# UNITED STATES PATENT AND TRADEMARK OFFICE

10/594,315

<b>Office Action Summary</b>	<b>Application No.</b> 10/594,315	<b>Applicant(s)</b> KENNEDY ET AL.	
	<b>Examiner</b> RYAN DODD	<b>Art Unit</b> 3655

## **DETAILED ACTION**

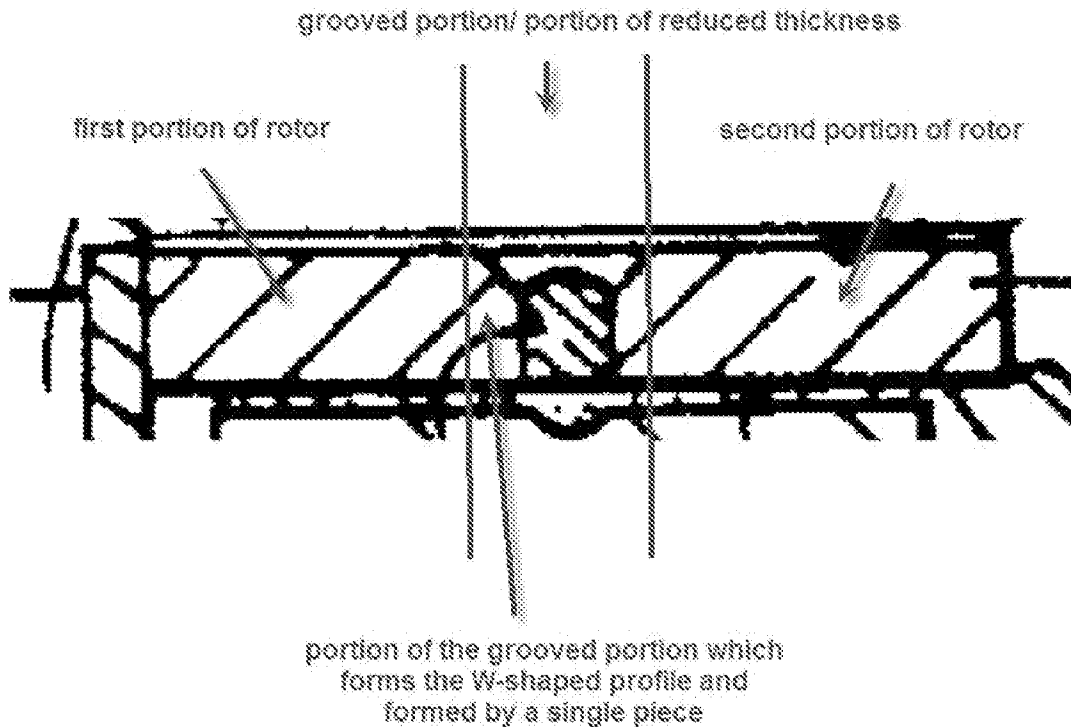
Maji '582 discloses, referring to Fig. 5 a viscous fluid clutch for use in a vehicle comprising:

- a rotor (cylinder 5, is rotated, see column 1, line 24) having a rotor hub (side plate 7) driven by an input shaft (4) and a rotor surface having an end connected to an outer periphery of the rotor hub,
- the rotor surface including: a first portion; a second portion; and a grooved portion disposed between the first and second portions;
- wherein the grooved portion forms a W-shaped profile, wherein a portion of the grooved portion which forms the W-shaped profile is formed by a single piece (see Fig. 5 and figure below);

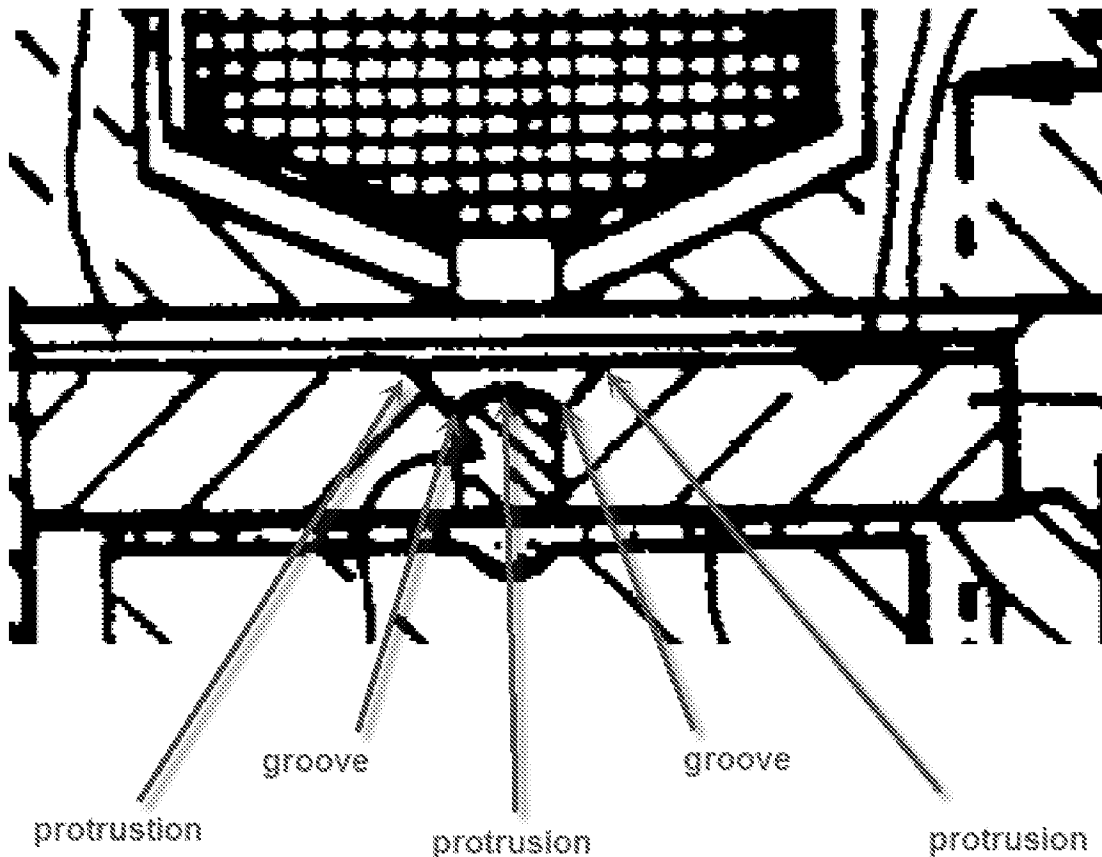
- an input shaft (4);
- a coil assembly (8) for generating a magnetic field;
- a housing comprising a stator (rotor 20); and
- a rotor (cylinder 5, is rotated, see column 1, line 24) disposed in the housing; wherein the rotor includes a radially extending hub (7) driven by the input shaft and an annular rotor ring connected to the hub; and
- wherein the rotor ring includes a first portion, a second portion, and a portion of reduced thickness (see Fig. 5 and figure above) disposed between the first and second portions to prevent a shunt in the magnetic field, and

- wherein the portion of reduced thickness is formed to include grooves and protrusions (see figure below).
